15. 556 EL CAMINO REAL, ZONED R-3 – APPLICATION FOR ENVIRONMENTAL REVIEW, DESIGN REVIEW AND CONDOMINIUM PERMIT FOR A NEW 25-UNIT CONDOMINIUM BUILDING (ROMAN KNOP, APPLICANT; DOMINGUEZ ASSOCIATES, DESIGNER) STAFF CONTACT: KEVIN GARDINER

Date: Revised Plans Submitted March 25, 2015

From: Planning Staff

Methods for improving circulation:

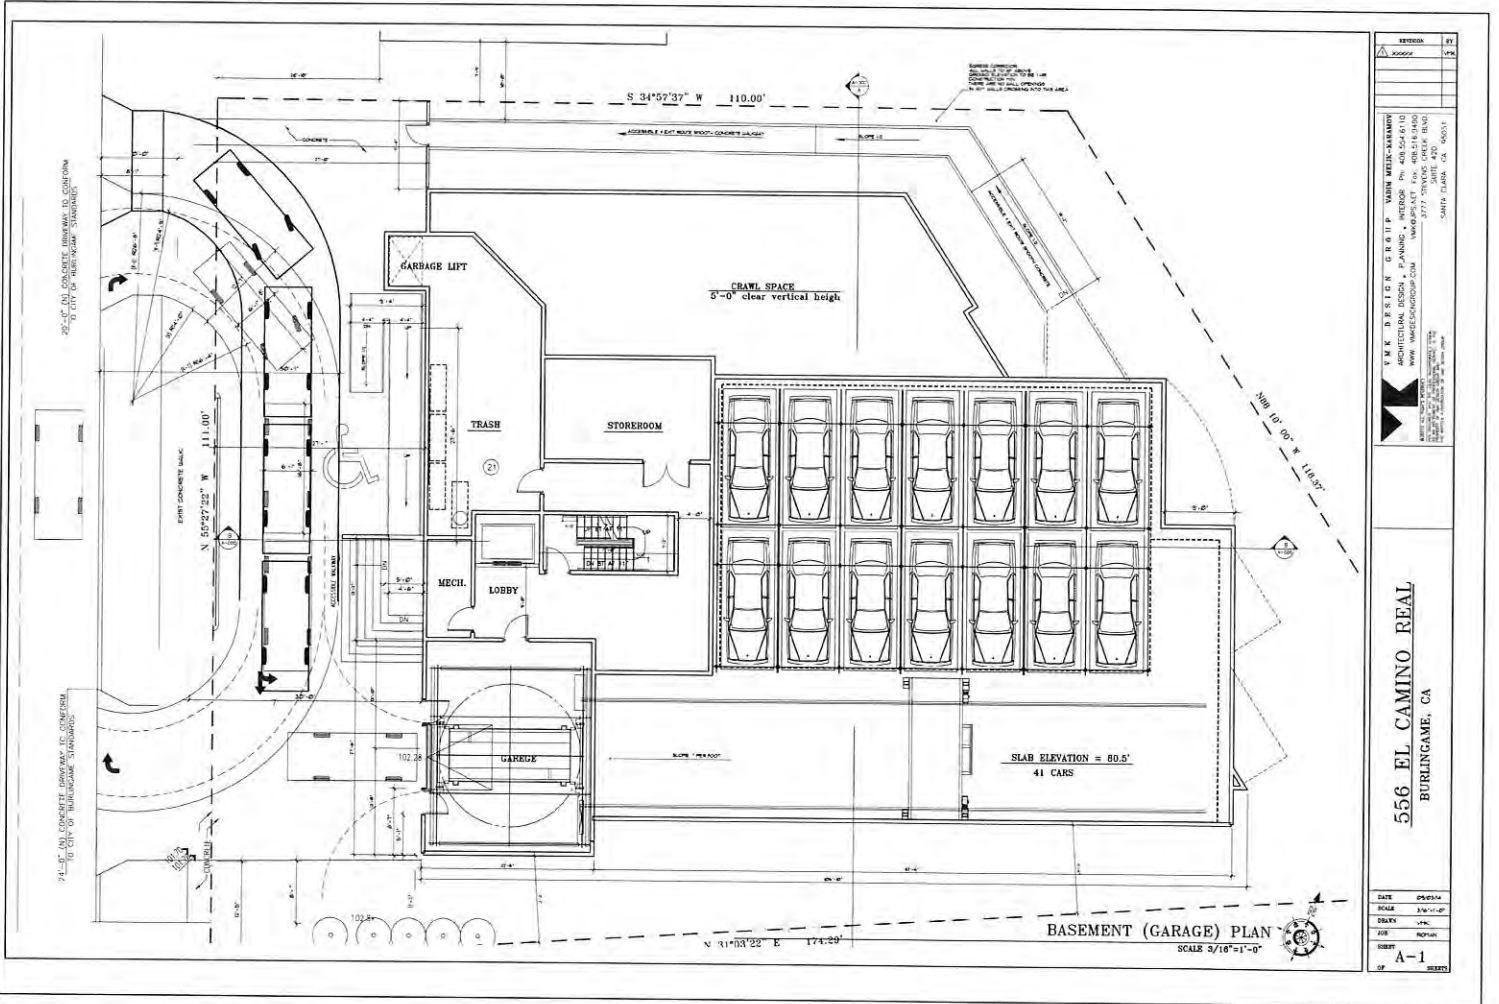
It appears that room for a fourth car is almost available in the current design. Pulling building back from El Camino would only add one car, there is not enough space to add any more and maintain a single line. Extending the driveway closer to the property line would be more effective since there is more space to increase driveway length. Regardless, alternative means may be preferable to avoid backup on El Camino Real. My recommendations are summarized below:

- Lengthen driveway towards the property's westerly boundary. This shift would be more effective than pulling back from El Camino since there is more space in that dimension.
- A fourth car would create a factor of safety of 33%, which seems adequate for this project.
- Notify future residents that blocking ECR is not allowed. If the queue is full, residents must circle the block.
- Provide signage to this effect as requested by traffic engineer.
- Paint stripes in driveway to place cars in order. This could prevent excessive separation between cars and show incoming residents whether all spaces in the queue are full.
